13 December 1955

SUBJECT : Specification of 9 $\frac{1}{2}$ " Continuous Printer Printing Drum.

Attachment:
Sketch a/s in para 2.

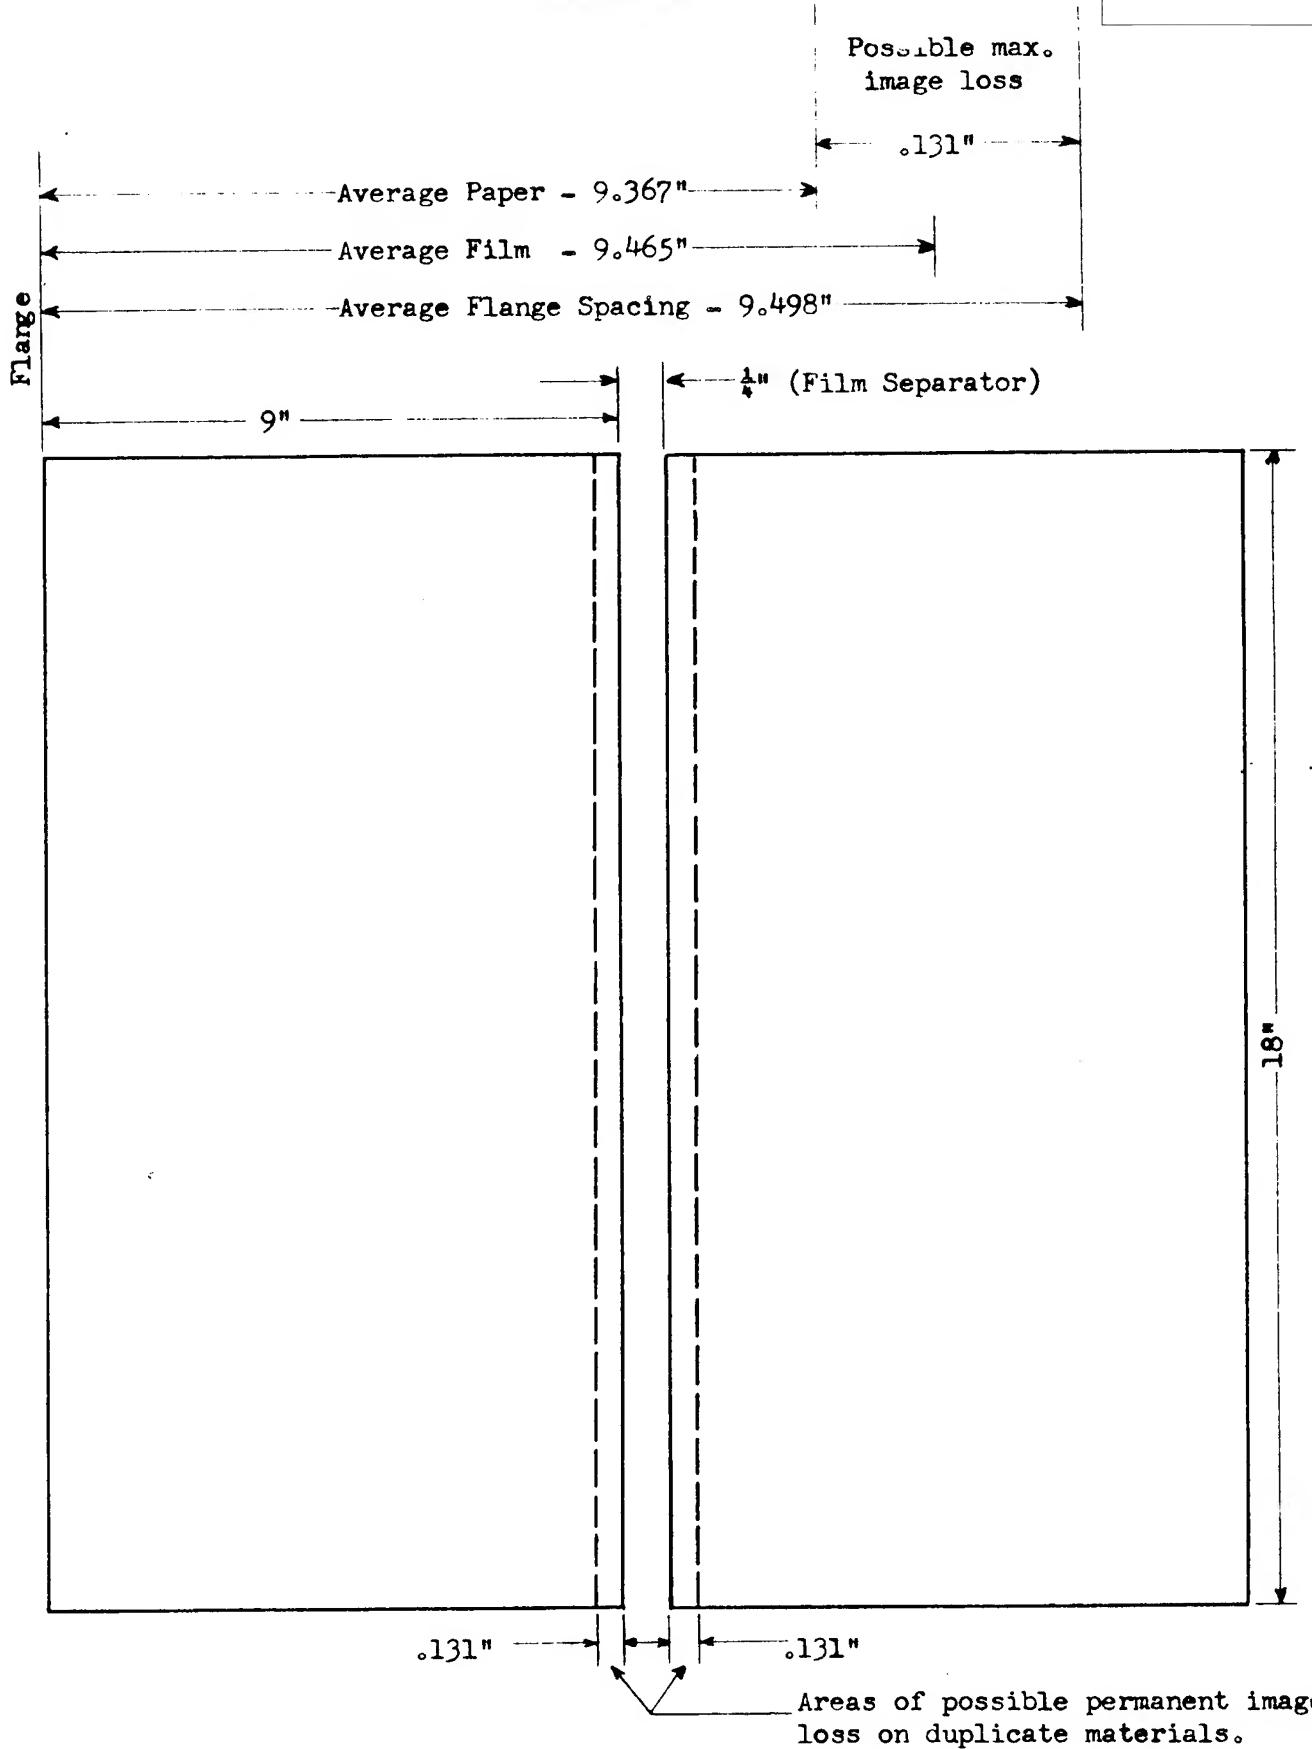
2. The earlier discussions were initiated to determine the feasibility of providing a protective edge on duplicate material from the B and C cameras. This edge is still desirable but the dimensions provided by [REDACTED] indicate a possible loss of image area in the preparation of duplicate material. The attached sketch indicates the possible loss of image which may occur. The loss of any image area is felt to be very serious and should be prevented if at all possible.

$$\left(\frac{.131}{12}\right) \times 2 \times \frac{70,000}{(36/12)} = 509^{\circ} = \text{Possible loss of coverage in duplicate materials.}$$

3. It is recommended that Eastman Kodak be contacted to determine the feasibility of altering the printing equipment so as to insure the retention of all image area of the negatives from the B and C configurations.
